**From:** Lindsey Ozbolt  
**Sent:** Friday, January 27, 2017 4:18 PM  
**To:** 'Nate Thompson'  
**Subject:** RE: ELST 60% Plan Homeowner Feedback - 2325 East Lake Sammamish PL SE - Signed Letter

Subject: East Lake Sammamish Trail Segment 2B

**From:** Craig [mailto:craig.o@comcast.net]  
**Sent:** Friday, January 27, 2017 8:01 AM  
**To:** Lindsey Ozbolt <LOzbolt@sammamish.us>  
**Cc:** Lyman Howard <lhoward@sammamish.us>; Don Gerend <dgerend@sammamish.us>; Tom Hornish <THornish@sammamish.us>; Kathleen Huckabay <KHuckabay@sammamish.us>; Bob Keller <BKeller@sammamish.us>; Christie Malchow <CMalchow@sammamish.us>; Tom Odell <todell@sammamish.us>; Ramiro Valderrama-Aramayo <RValderrama-Aramayo@sammamish.us>  
**Subject:** Comments/Questions for ELST 60% Design & SSDP

**RE: East Lake Sammamish Master Plan Trail South Sammamish Segment B**

Trail with fence erected by homeowners on water side:

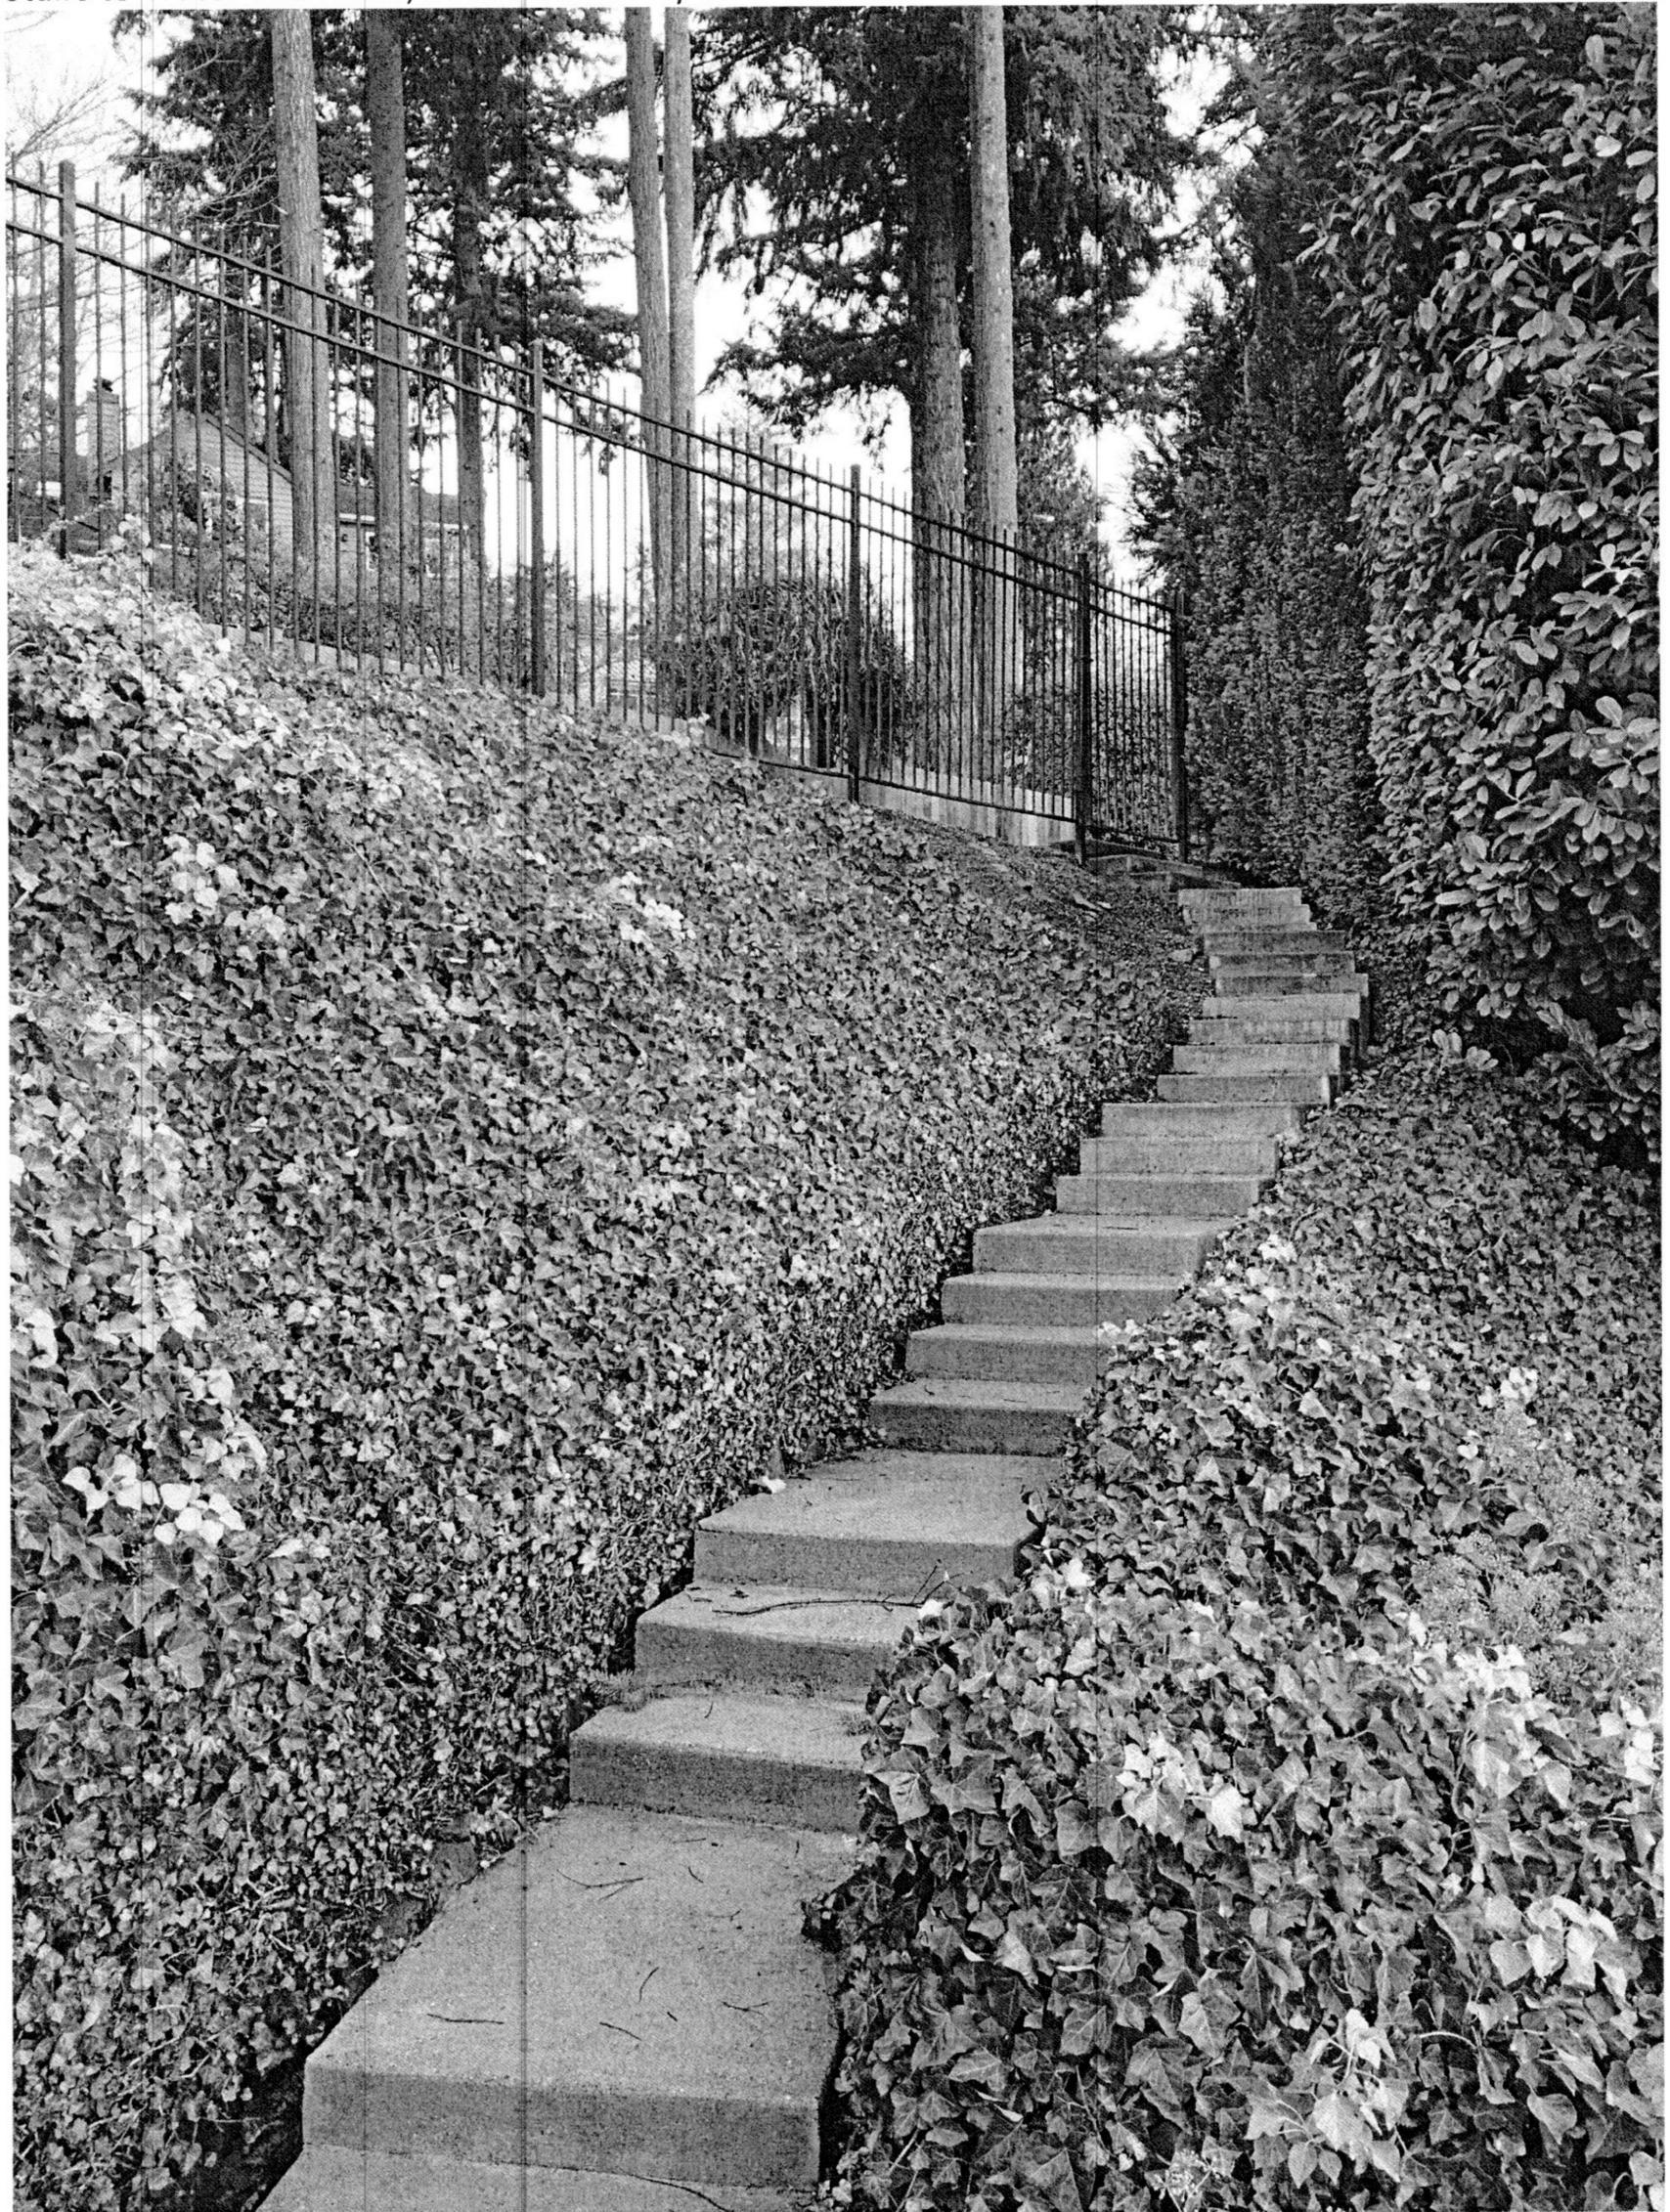
- 1) Currently the plans do not show fencing being replaced along either side of the trail. This is concerning for several reasons.
  - a. First, on the water side, there is a steep drop to the lake and a significant amount of that is comprised of large boulders and rocks. A trail user veering off the trail onto this slope – especially at any significant speed – will be at risk for grave physical harm. What is the rationale in removing the fencing that is there today, and not replacing it? We request that this is addressed by the current fencing, which was installed at the expense of the community homeowners, to remain in place during and after construction, or,

- b. replacing the fencing on the water side of the trail with fencing comparable to what is in place today including a gate for access.
  - c. Second, there is no fencing replaced on the uphill side of the trail. We have both small children and pets – the current fence keeps them inside the yard safely. It also keeps trail users on the trail and not in our yard. Providing unfettered access onto the trail from our yard, and into our yard from the trail is not safe for our family, or trail users. We request that this is addressed by replacing the fencing on the uphill side of the trail, or we replace it, with fencing comparable to what is in place today including a gate for access.

View of Backyard area proposed to be developed into Rest Stop:

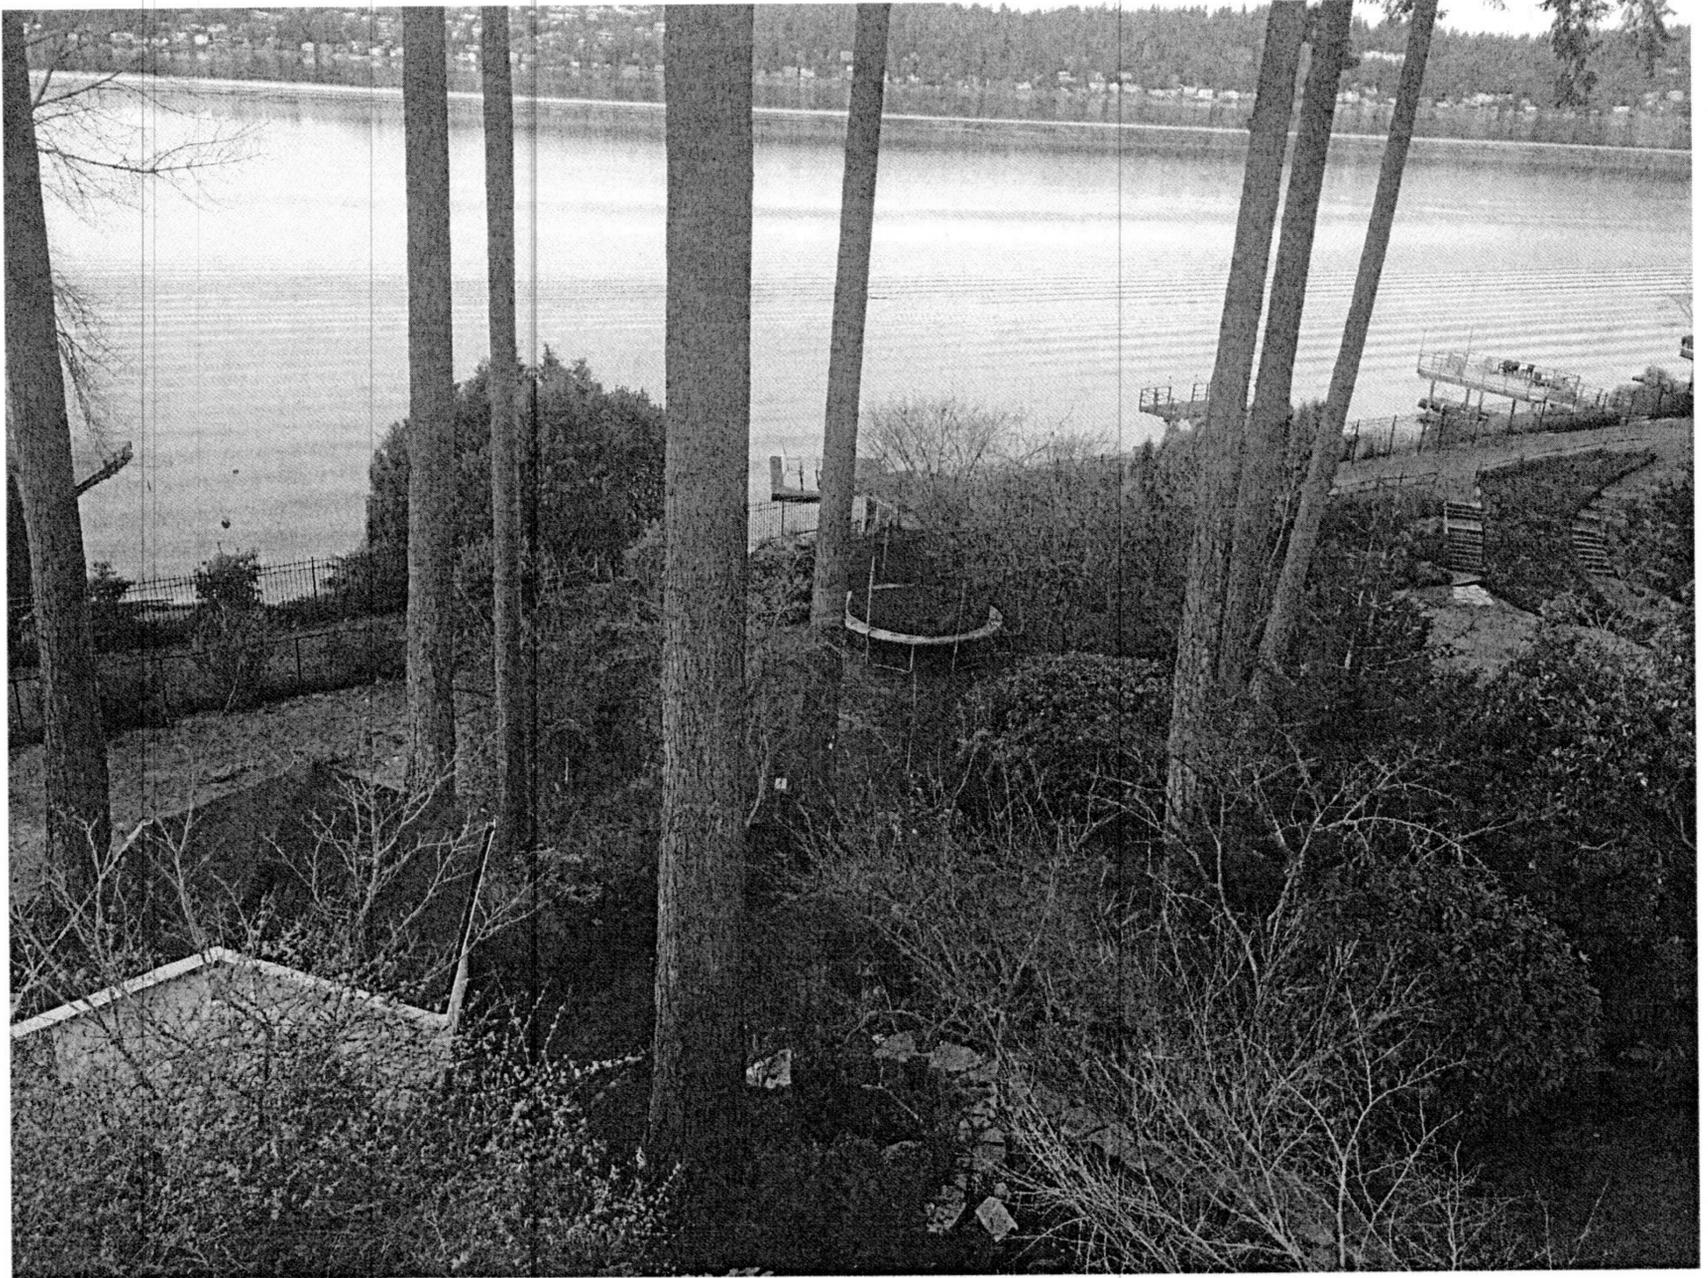
We are highly concerned about the decision to include a rest stop (note 12) in our yard. We have a number of questions, and for several reasons we urge you to consider removing it or moving its location.

- 9) Nowhere else on the 60% plan do we see a rest stop being proposed in someone's back yard. We request that it is removed from our yard, and either moved or eliminated given the proximity to a much larger rest stop shortly up the trail.

**Photo #1 - View Looking North**

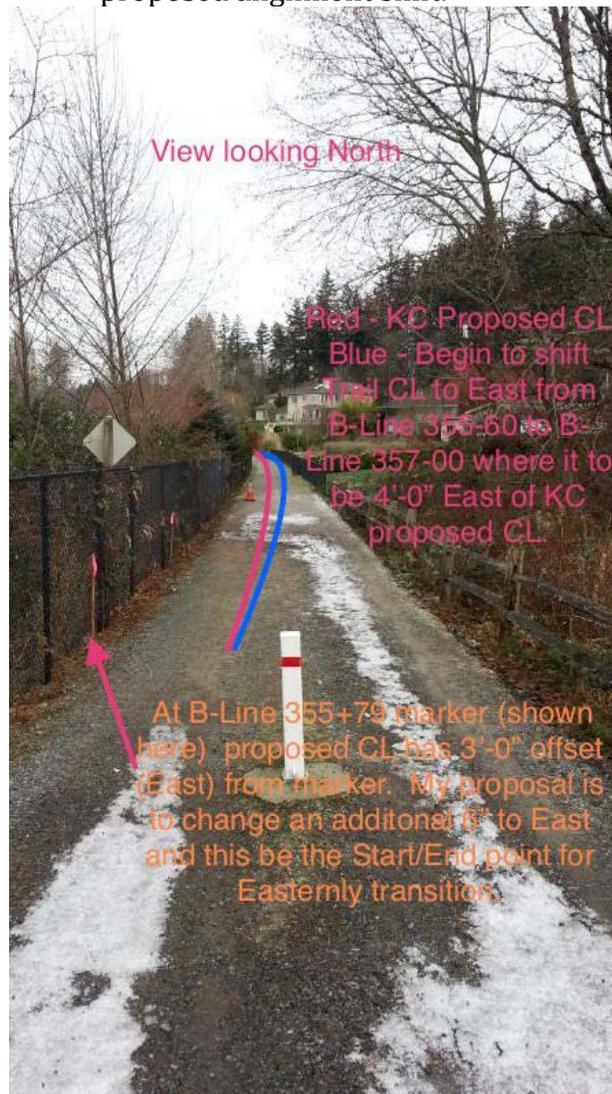
**The following is our proposal to shift the centerline as currently proposed in the 60% Design plans to the existing centerline of the current Interim trail.**

- i. Owner's Trail centerline (CL) Shift Proposal-
  1. Located at approximately B-Line 357-75 (moving North), begin a transition easterly to B-Line 357-00 where trail CL will be 4'-0" east of current proposed KC CL.
  2. At B-line 357-00, begin to transition back to existing proposed KC CL located at B-Line 359-00.
    - a. See Photos #1 - #4 below for a visual/graphical view of proposed alignment shift.

**Photo #2 - View Looking South**

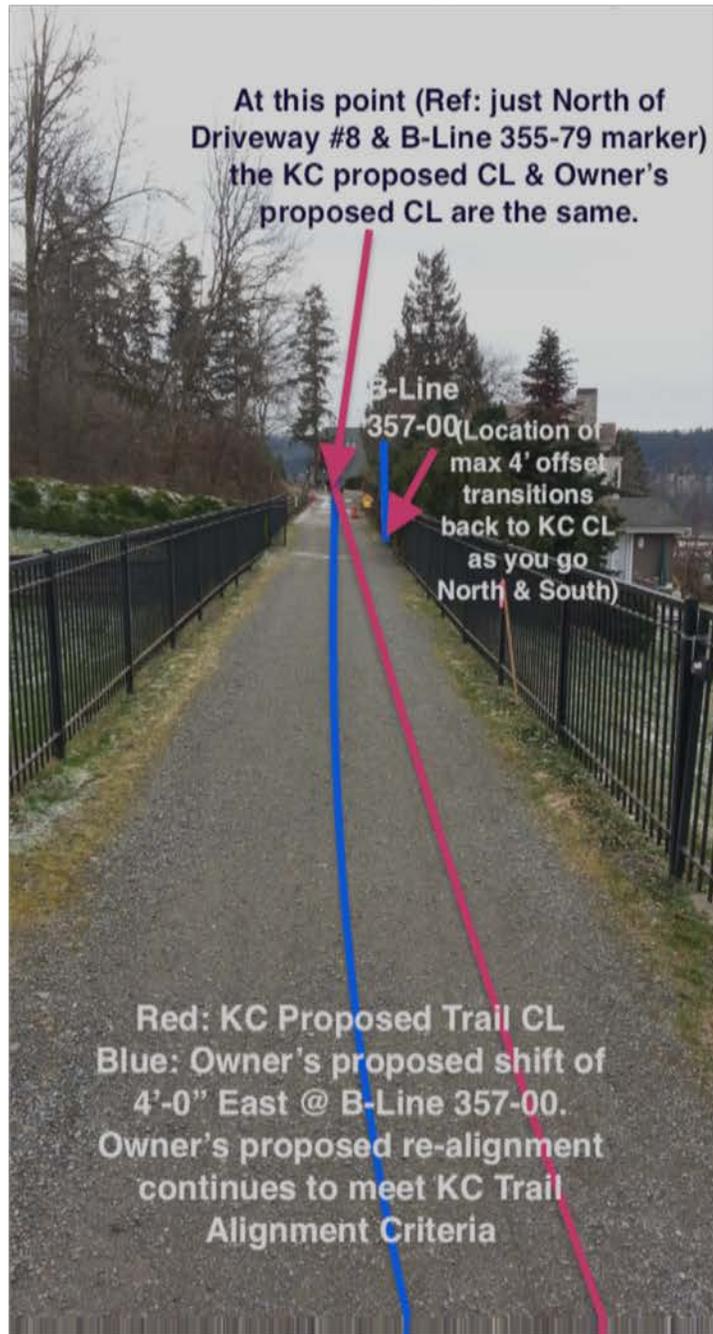
**IMPORTANT: Our proposal is to just shift the KC proposed centerline BACK to the center of the existing Interim Trail.**

Photo #7

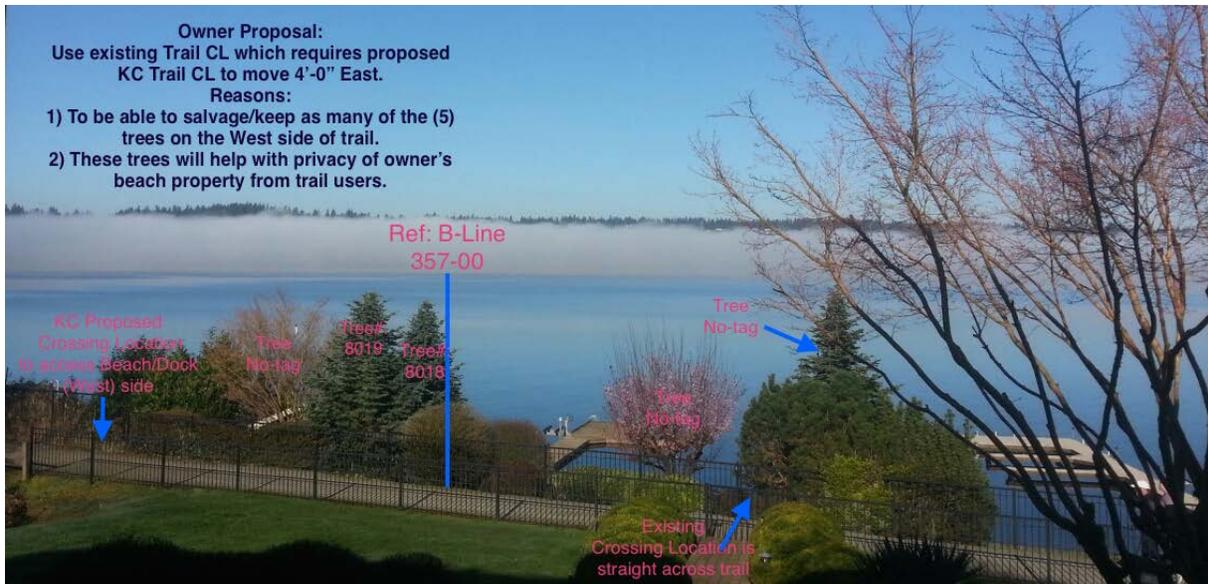
- a. Is this location on the Plans the final location or just a placeholder?
  - b. Why can't the location of our existing beach steps be maintained?
- c. Stair Design – There isn't a specific stair detail in the 60% Design Plan set but based on graphic detail, it is assumed KC/Parametrix plans on building one double stair set to be shared by two property owners.

- i. The stair type detail might meet the standard rise/run and handrail building codes, but it does not allow me to transport our lawnmower and other lawn maintenance equipment up/down the stairs safely without using two people. I maintain our own property so KC & the City if they approve this design are preventing me from maintaining our property and causes a safety issue for me trying to carry lawn maintenance equipment up/down the stairs as proposed.

1. Can the stair step design be changed with 3' to 4' runs to accommodate the transportation of lawn equipment up/down stairs and either match the curved design as we currently have or run the stairs East/West/ perpendicular to the trail? If no, provide reasons why these are not alternatives.

- a. Current Tree Preservation Plan called for Trees 8018 & 8019 to be removed. Accepting moving the trail centerline to the East (as proposed in Item 1 above) would possibility save or prevent the removal of these trees.

- i. Why wasn't the one coniferous tree (Alpine Fir) described in b) above marked or indentified in the Tree Preservation Plan if it has the same trunk size as Tree 8018 & 8019?

- ii. I understand that the deciduous trees do not meet the “significant” status as defined by King County, but provide significant screening for our beach property from trail users. Are these deciduous trees in b) above planned to be removed during construction?

1. What can be done to preserve these trees (25+ years old)?
      - a. NOTE: Shifting the trail to the East would ensure these additional trees could be saved and maintain this security and privacy for us from trail users.

- c. See the Photo #7 below that visually explains our comments and questions noted above.
